**QUALITY ASSURANCE -- NON-CONFORMANCE REPORT**

**Location:** Changxing Island, Shanghai, PRC**Report No:** NCR-000470**Prime Contractor:** American Bridge/Fluor Enterprises, a JV**Date:** 04-Nov-2009**Submitting Contractor:** Zhenhua Port Machinery Company, Ltd (ZPMC), Changxing Island**NCR #:** ZPMC-0443**Type of problem:**

**Reference Description:** Missed UT indications on Tower Spare Strut**Description of Non-Conformance:**

**Job Name:** SAS Superstructure  
**Document No:** 05.03.06-000433

WELD NUMBER: WD1-A6003-2-12A/B Note: Remove only by grinding

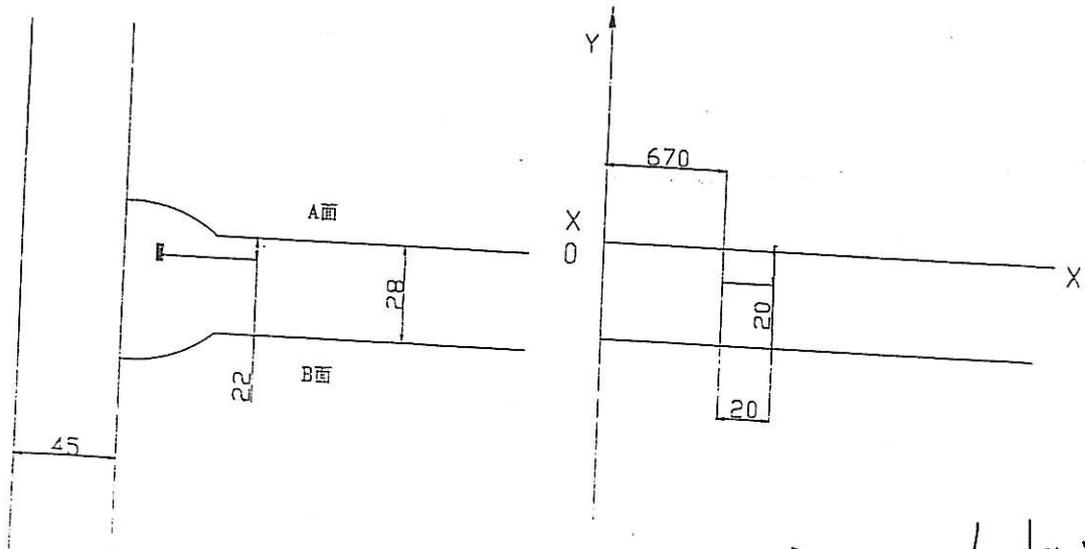
Description of welding discontinuity:

Rejected indication found by ultrasonic inspection is less than the maximum allowance aggregate length.

(UT探伤发现的缺陷总长度小于最大允许长度) WD1-A6003-2-12A/B

- 1、 无打磨,焊接接头没有有效打磨;
- 2、 起弧和收弧没有交错布置,以将焊渣减少到最少;
- 3、 焊道清理没有有效的清理。

1. The weld joint was not ground sufficiently after arc-gouging.
2. The arc starts and stops were not staggered to minimize slag entrapment.
3. Interpass cleaning was not performed properly.

1. Gouge off the defect weld;
2. Grind smoothly the gouged surface;
3. If User's request, check with MT or other NDT method to make sure the defect remove completely;
4. Preheat and the interpass temperature control according to the relative WPS-repair;
5. Check the welding according to the approved shop drawing.

1. 切割后的接头位置打磨要过渡, 保证每道焊缝的接头可以交错布置;
  2. 认真仔细检查每道焊缝和加强焊缝的清渣;
  3. 焊缝中所有的焊渣全部去除后, 表面的缺陷全部打磨干净.
1. The joint shall be ground to a smooth transition to ensure that arc starts and stops are in a staggered Arrangement.
  2. QC shall inspect the weld passes more carefully and enforcing interpass cleaning.
  3. All weld slag shall be removed and surface defects ground during interpass cleaning.
